**Regulations 49 and 83 – LPG reference fuel**

**Document GFV-02-2**

**Proposals for Draft Amendments and Comments to  
Regulation 115**

**Document GFV-02-4**

**Relative emission versus time for vehicle A (Euro 4) in the urban part of the type 1 test** (Source: Environmental Protection Centre, Motor Transport Institute, Warsaw, Poland)

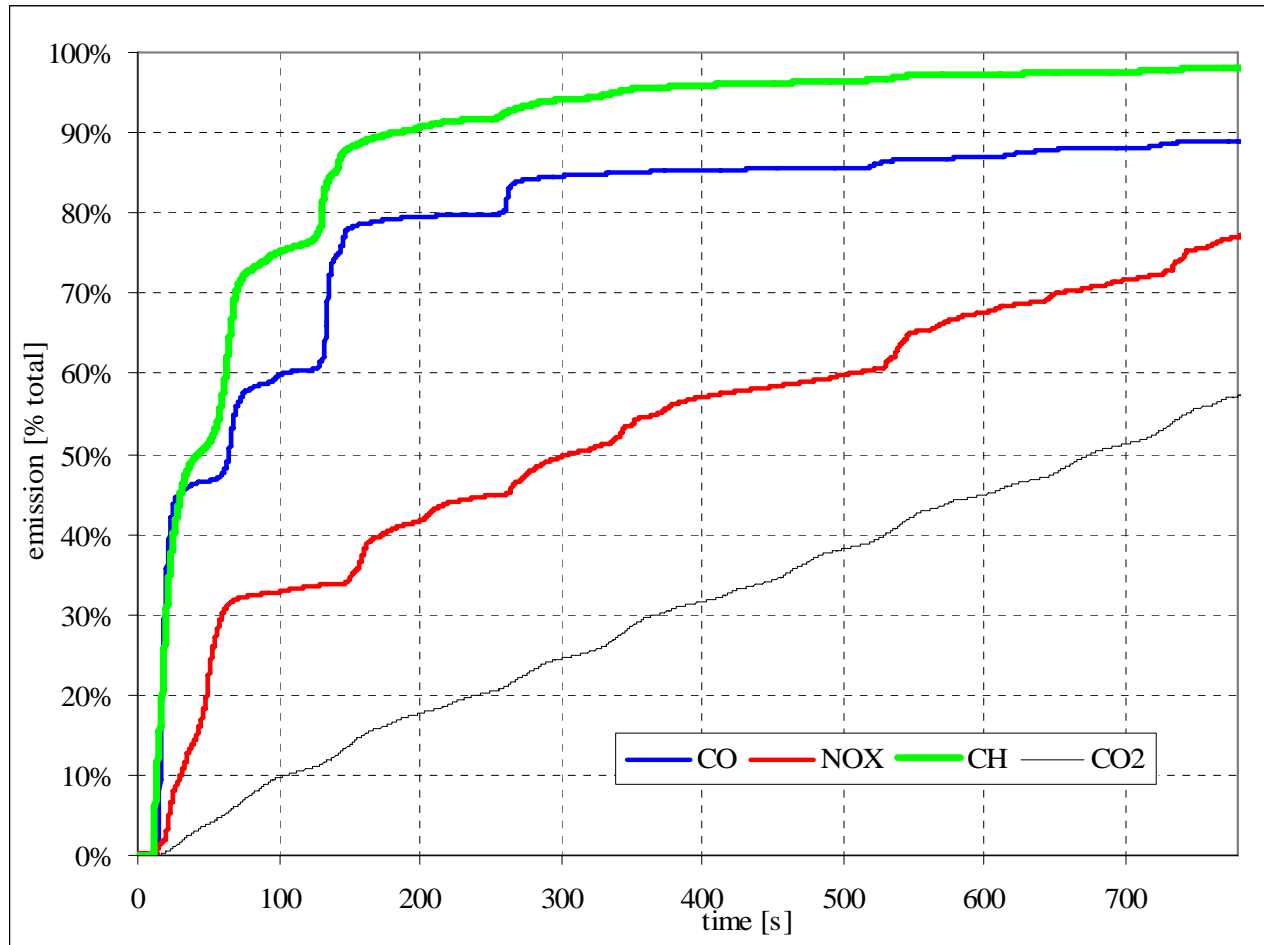
The ratio of the actual emission with petrol to the limit value is usually in the order of 40% - 60% for Euro 3 and Euro 4 vehicles. If:

- it is equal to 40%,
- the relative emission versus time curve is similar to those shown above,
- and the switch over time is 60 s,

**the emission with LPG may be even about 5 times higher than that with petrol** and the vehicle is deemed to comply with the requirements of Regulation 115 for “non-intrusive” retrofit systems.

**LPG/petrol emission ratio for different ratio of actual emission with petrol to limit (40%, 60% 80%, 100%) for “non-intrusive” retrofit system**

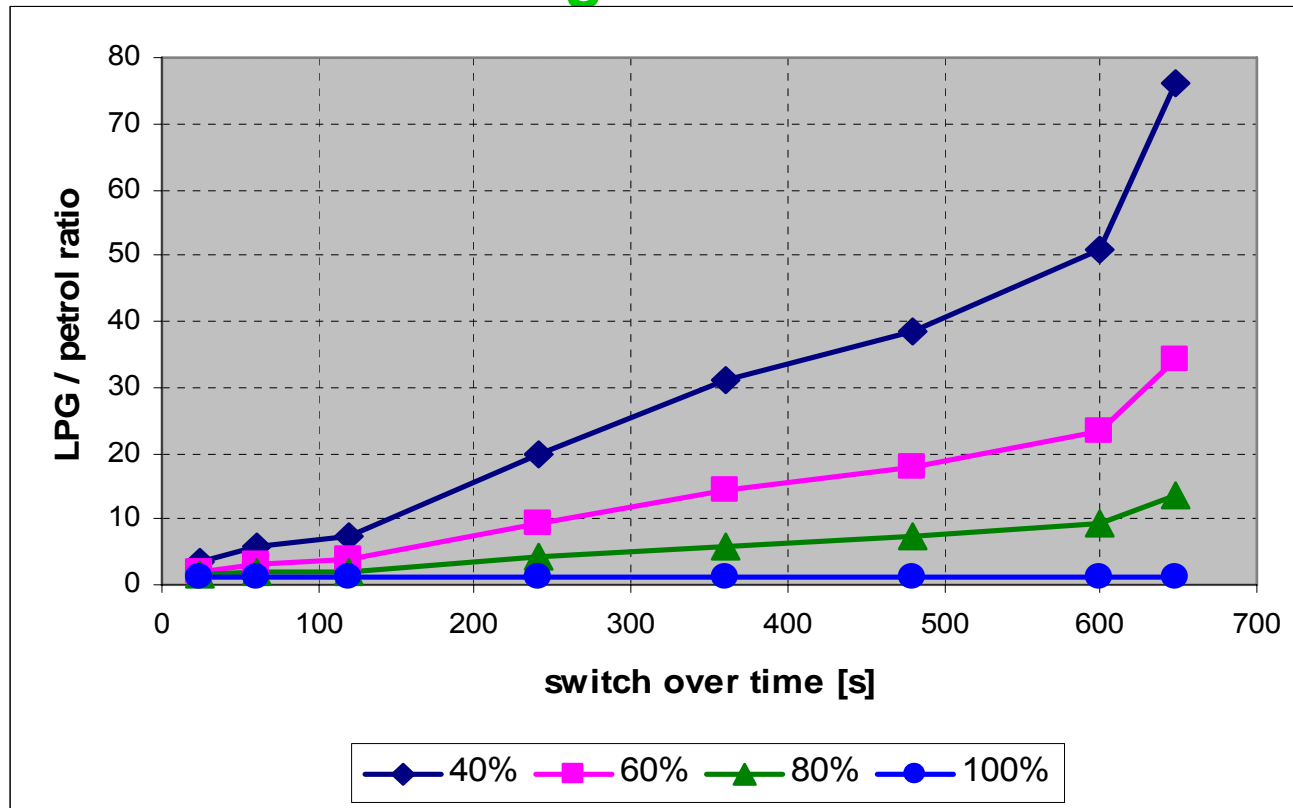
In Figure above the switch over time varies from 25 s (the shortest time found) to 648 s (the longest time found). If:

- the ratio of the actual emission with petrol to the limit value is 40 %,
- the switch over time is 648 s,
- and the relative emission versus time curve is similar to that shown above,

**the emission with LPG may be even 70 times higher than that with petrol and the vehicle is deemed to comply with the requirements of Regulation 115 for “non-intrusive” retrofit systems.** Even when the switch over time is 25 s, the emission with LPG may be 3 times higher.
